# REVIEW COMMENTS

FILE #137-93

TITLE HEADING: Site Plan Review - Antler Art

LOCATION: 2517 Weslo Court

1  
SP1
**SITE PLAN**  
 SCALE: 1" = 10'-0"

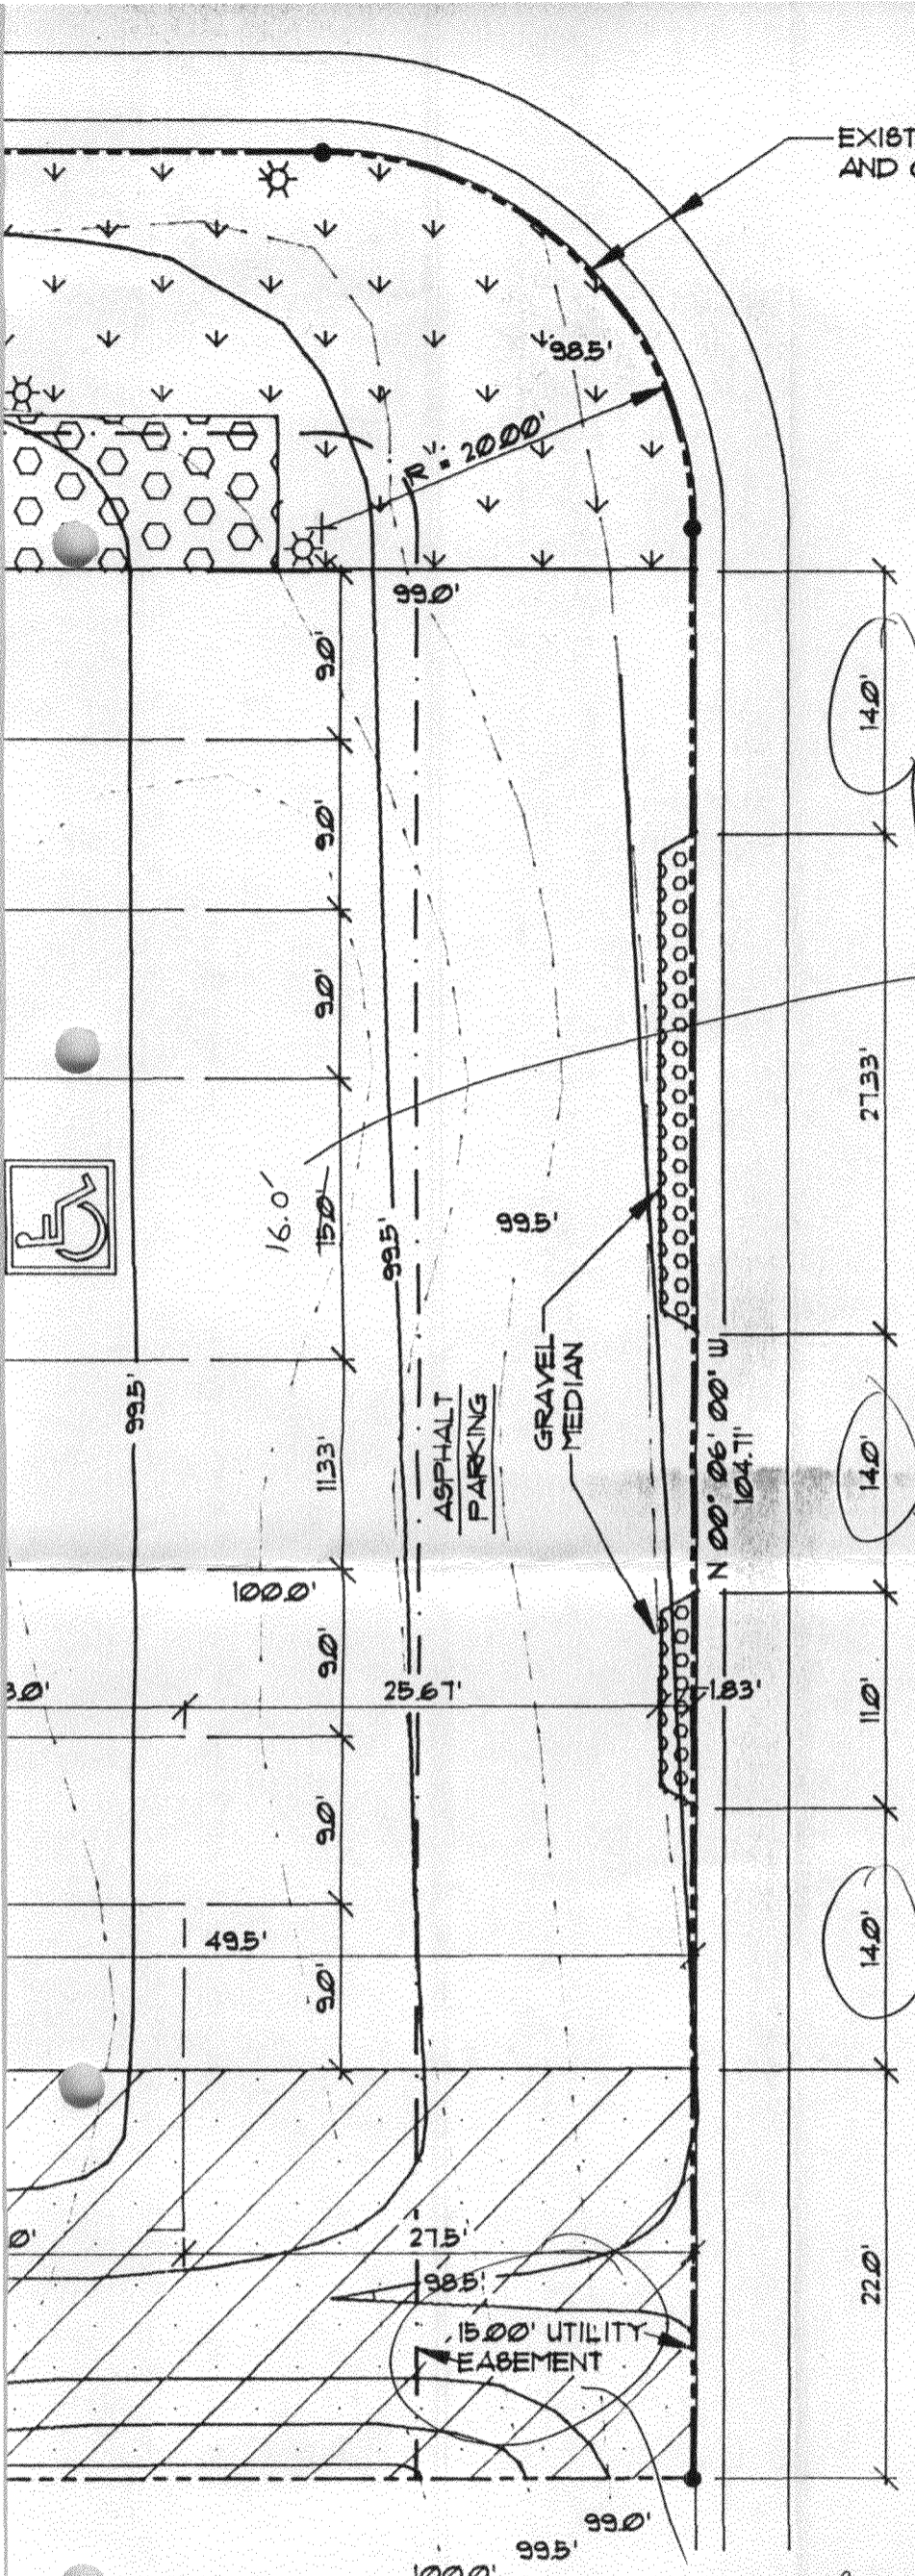
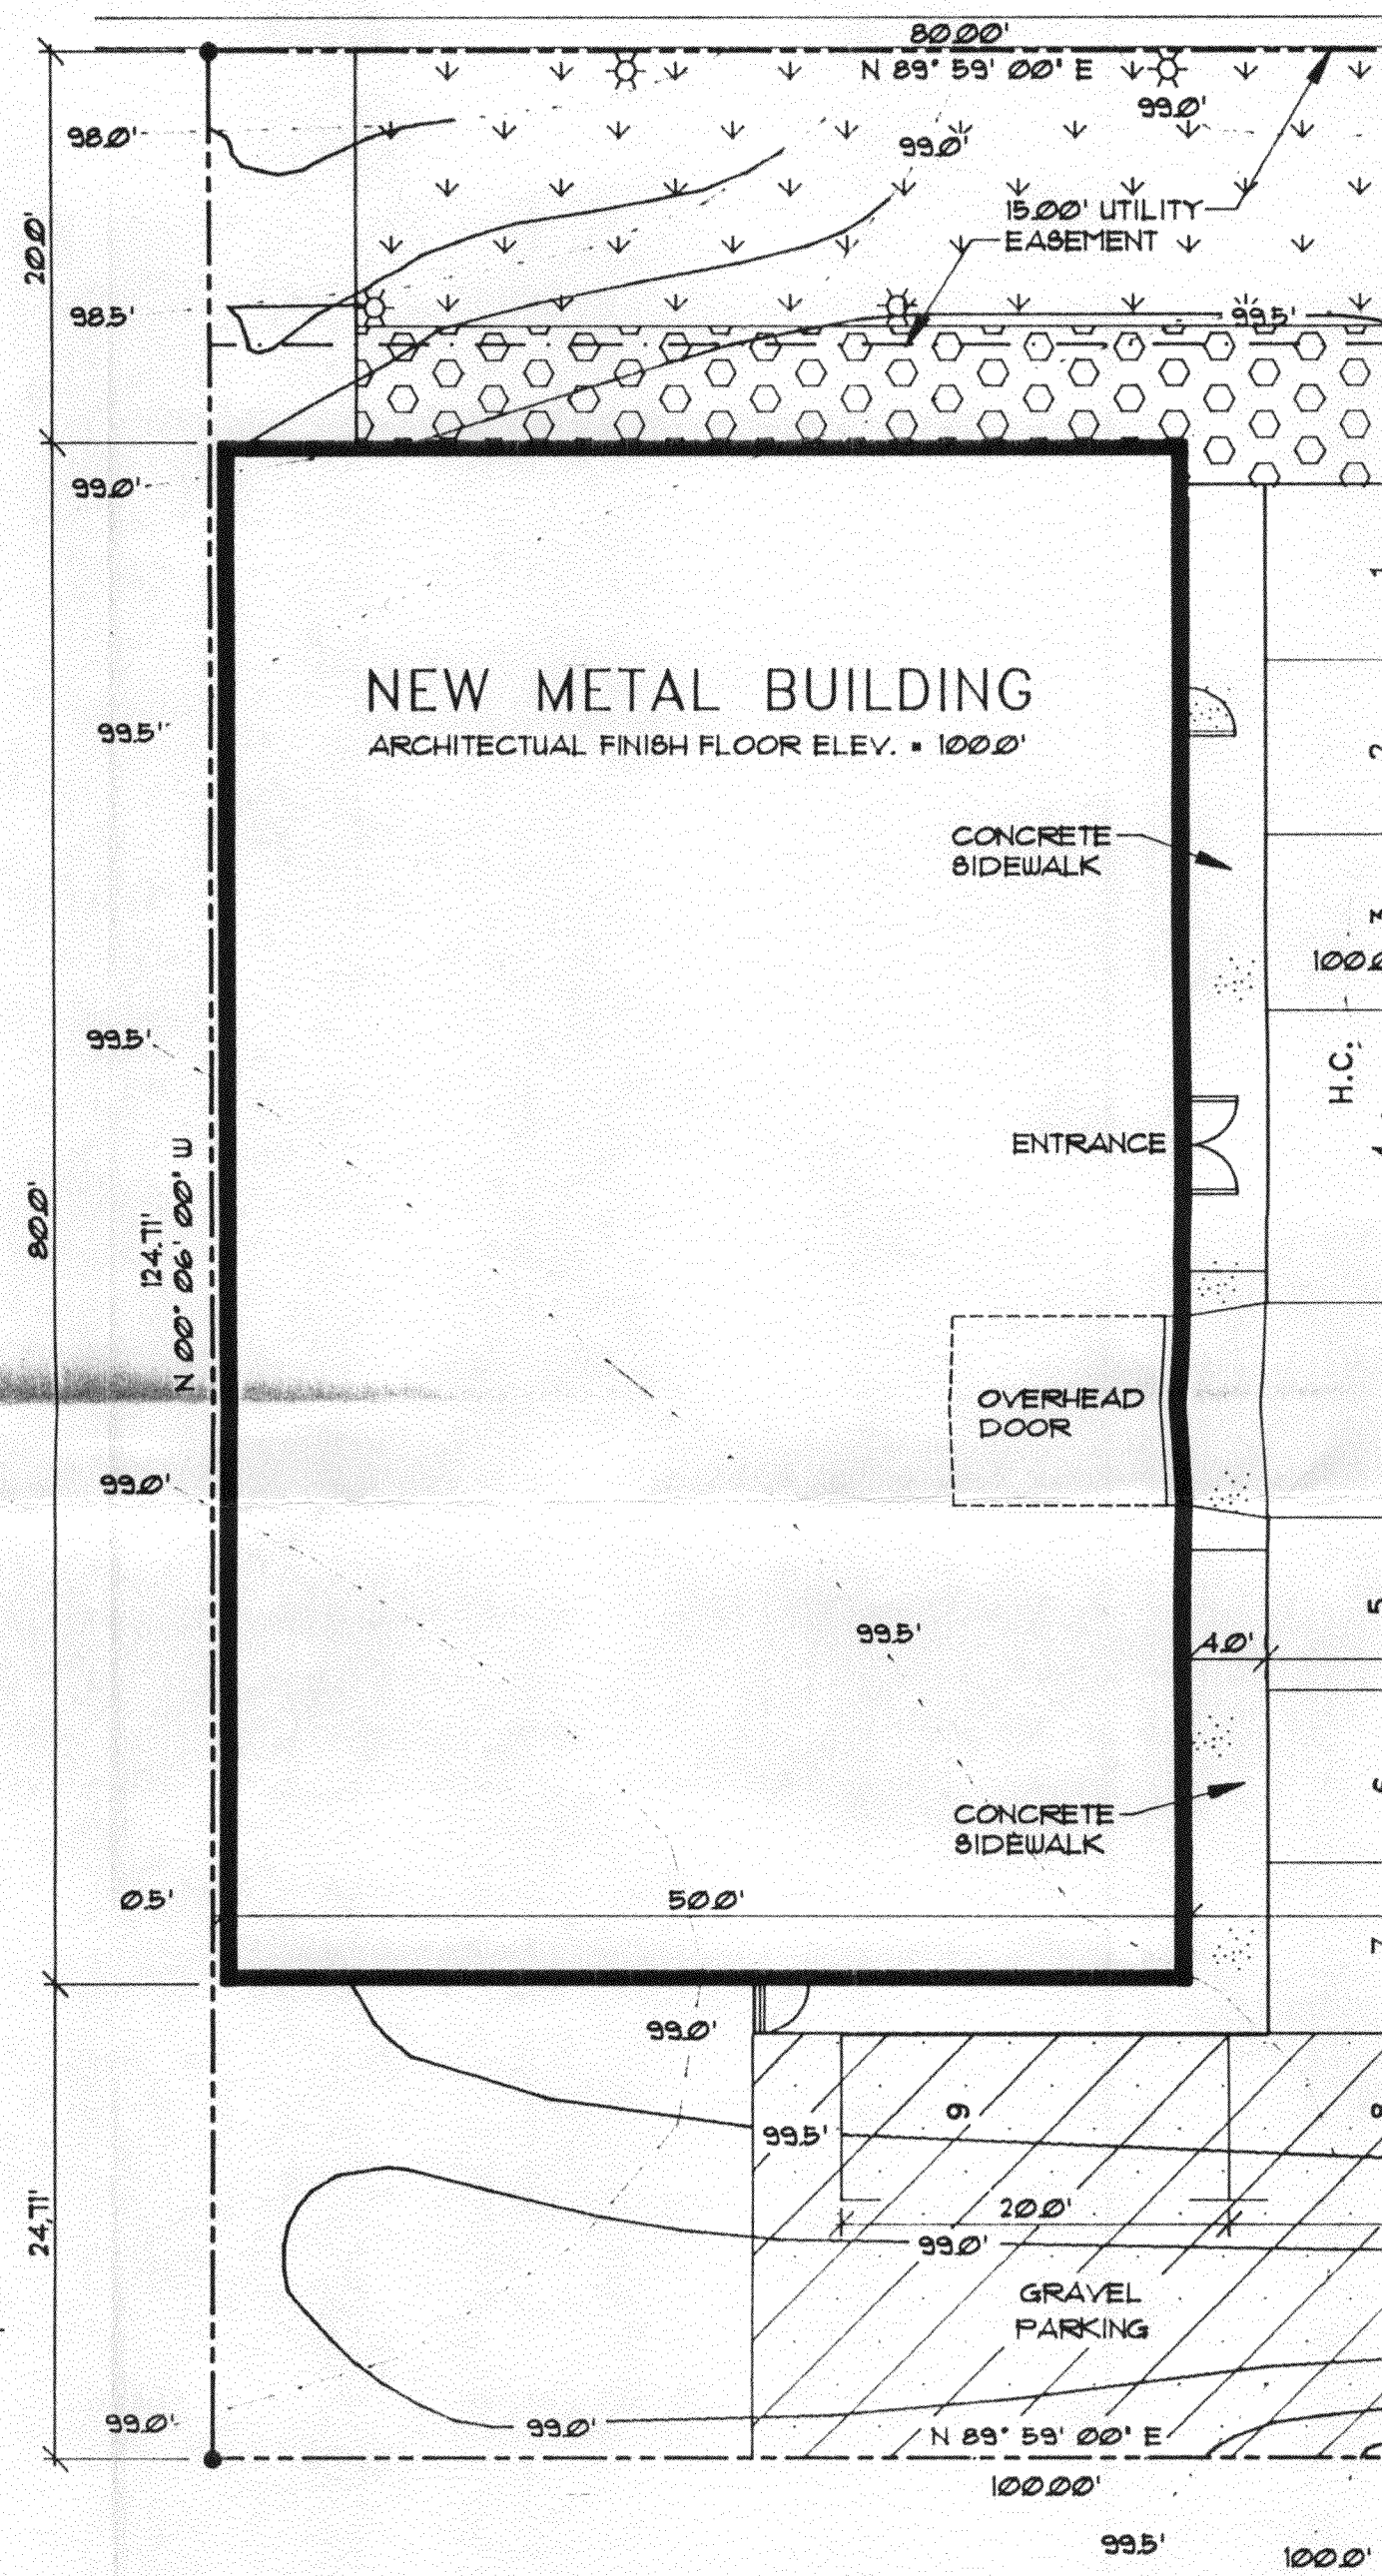
which is acceptable if  
the shrubs that were required

As Per City Std. Detail should be an 8' stall with an 8' access aisle. Accessible parking sign must be installed also.

Unless the parking area and the sidewalk are the same elevation, a ramp is required as per city std.

Driveways need to conform to attached curb cut standards. Will probably be limited to two.

Is this a recorded easement? If so, please provide book and page number.
